**Town of Rotterdam
Planning Commission
June 20, 2023**

Agenda (7:30pm):

WAIVER OF SITE PLAN REVIEW

TOTAL OF TWO EDITIONS THIS EDITION IS THE ONLY VALID ONE	10/07/2022		DATE C102	SHEET 2 OF 4
	1" = 40'			
	17029			
GRADING, DRAINAGE, E & SC PLAN

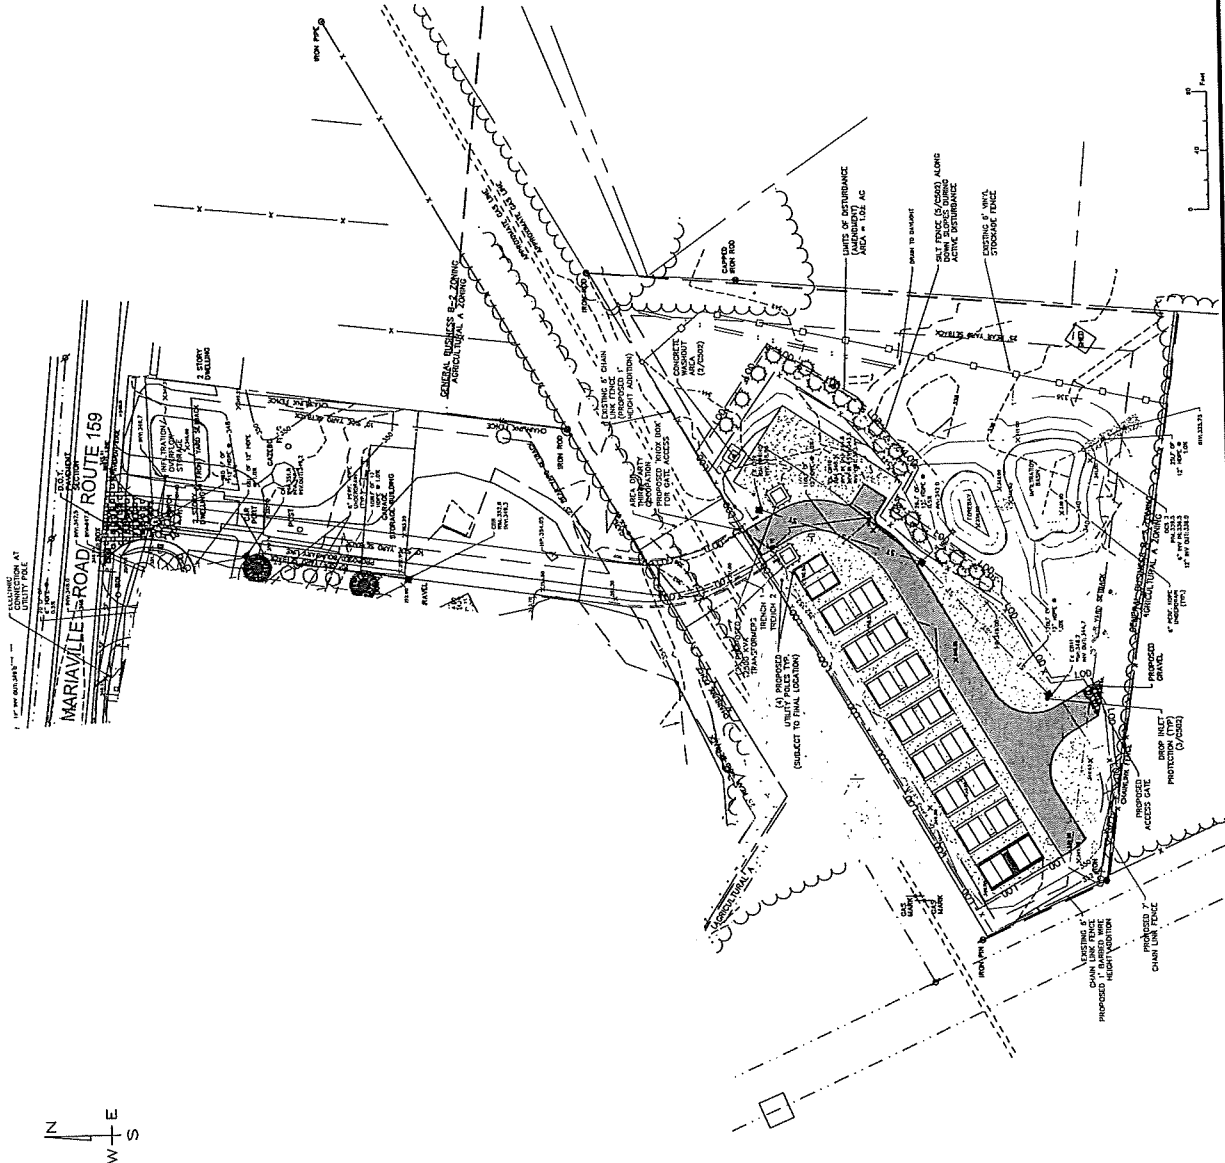
2. Sheet 1
 - a. Empire Engineering has submitted supporting comments and their letter is attached as **Exhibit A-2**
3. Sheet 2
 - a. With regard to the grading on the southwest portion of the site near the end of the proposed turnaround, please note corrections to two spot grades identified by TDE on **sheet C102**

- b. With regard to TDE request on identification of sediment protections, please find these notes added to **sheet C102**
 - c. With regard to designating a location on plans for the concrete washout and sediment traps details on **sheet C502 detail 2**, please note that a concrete washout area and sediment traps have been implemented on **sheet C102**.

- c) Please designate a location on plans for the concrete washout and sediment traps details that were provided on new Sheet 4.

Response: Sheet 2/4 shows locations for the concrete washout area. Since the existing catch basins will be equipped with The temporary sediment trap detail has been replaced with the drop inlet protection detail on Sheet 502.
